URGENT FIELD SAFETY NOTICE

Recall of Single Use Distal Cover MAJ-2315

Used with: EVIS EXERA III Duodenovideoscope TJF-Q190V, EVIS LUCERA Elite Duodenovideoscope TJF-Q290V, Duodenovideoscope TJF-Q170V

Original Design	New Design
Lot number	Lower than H2530	H2530 or higher
Overview		
Tear off line design change (Back view)

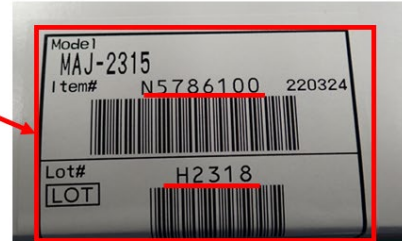
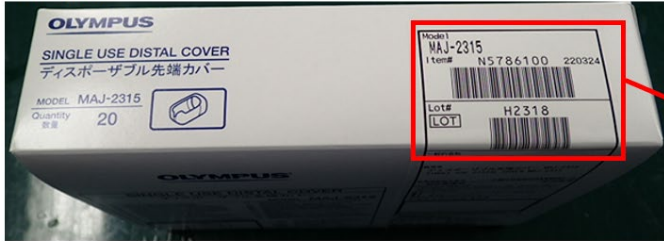
Olympus redesigned the distal cover and has observed a decrease in the referenced complaints. Olympus is initiating a medical device recall for distal covers with the original design (see the following table for a comparison). The recall does not impact the new distal cover design.

1. Carefully read the content of this Field Safety Notice.
2. Immediately locate and no longer use the MAJ-2315 with the original design. The original design can be identified by the item code (below) or by lot numbers less than H2530. The image below depicts the area where the lot number is identified. The lot number is on the Carton box and Pack.
